PMSTPCOL PEmails

February 10, 2010
U7-C-STP-NRC-100036

South Texas Project
Units 3 and 4
Docket Nos. 52-012 and 52-013
Response to Request for Additional Information

Attached are the responses to the NRC staff questions included in Request for Additional Information (RAI) letter numbers 299 and 302 related to Combined License Application (COLA) Part 2, Tier 2, Sections 3.7.1, 3.7.2 and 3.8.4.

Figure 03.08.04-17f: Comparison of DCD and STP 3 & 4 lateral soil pressure H' for design of RB Walls

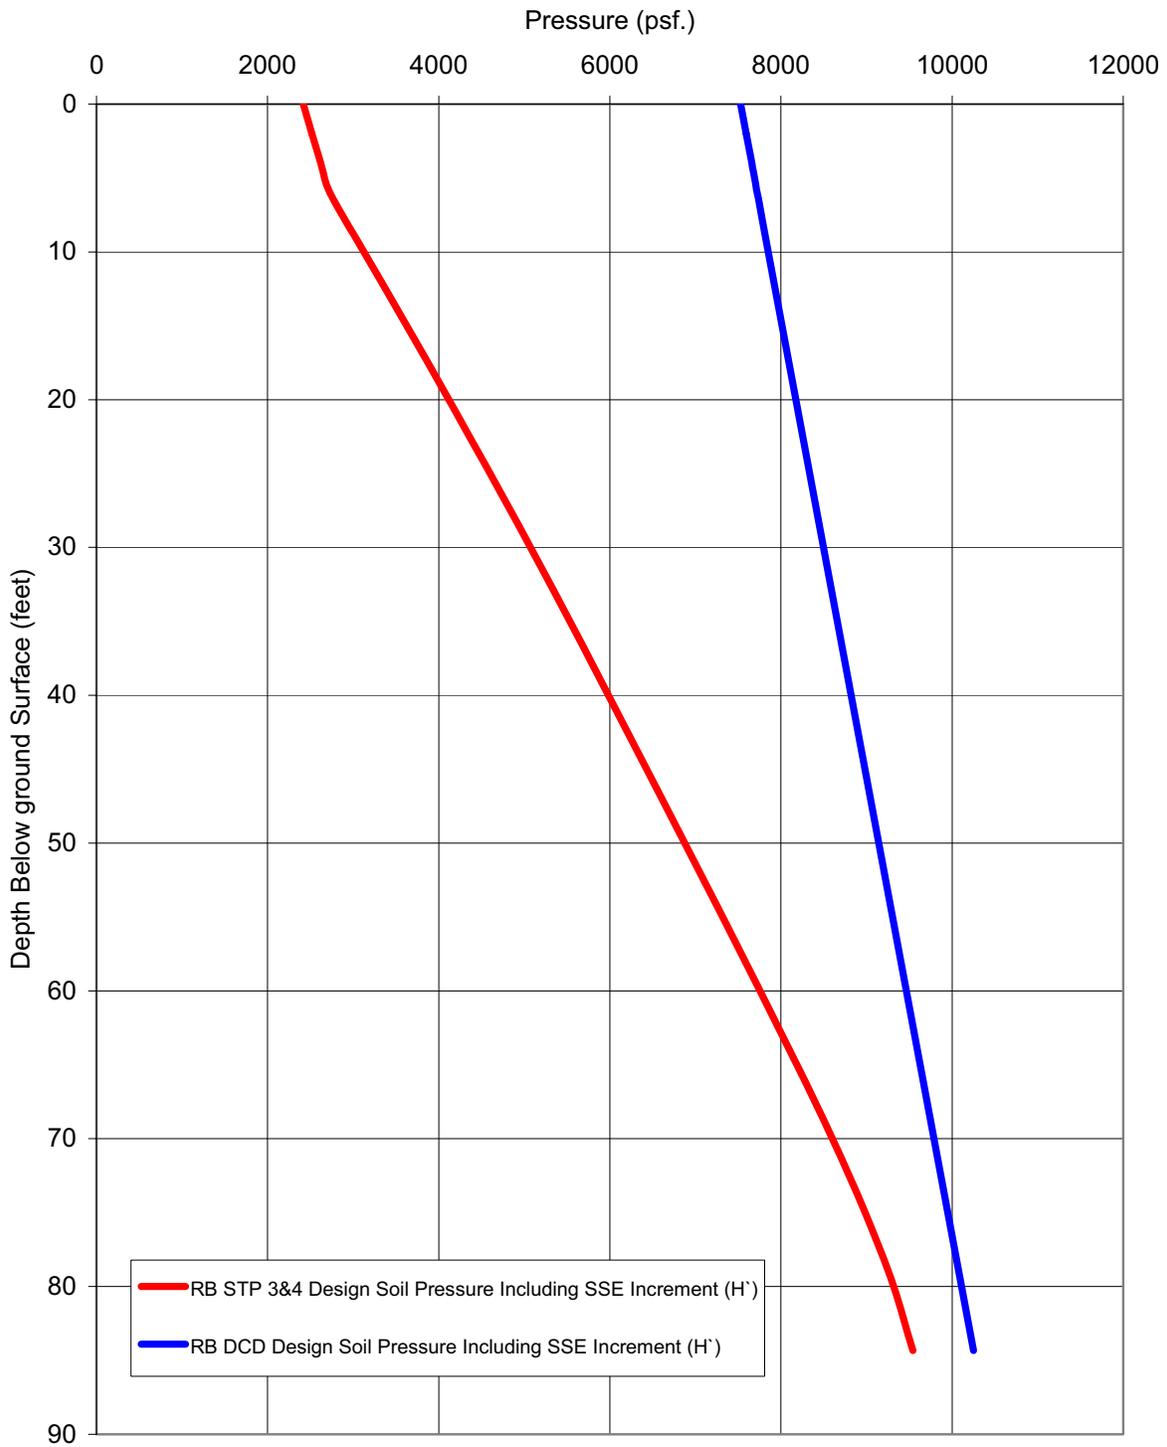
- b) Per Sections 3H.1.4.3.1.8 and 3H.1.5.5.3.1 of the ABWR DCD, Tier 2, the lateral soil pressures used for the design of Reactor Building (RB) walls are provided in Figure 3H.1-11 of DCD Tier 2. Also, per Section 3H.2.4.3.1.4 of DCD Tier 2, the lateral soil pressures used for the design of Control Building (CB) walls are provided in Figure 3H.2-14 of DCD Tier 2.

Figures 03.08.04-17a through 03.08.04-17l on the following pages provide the following:
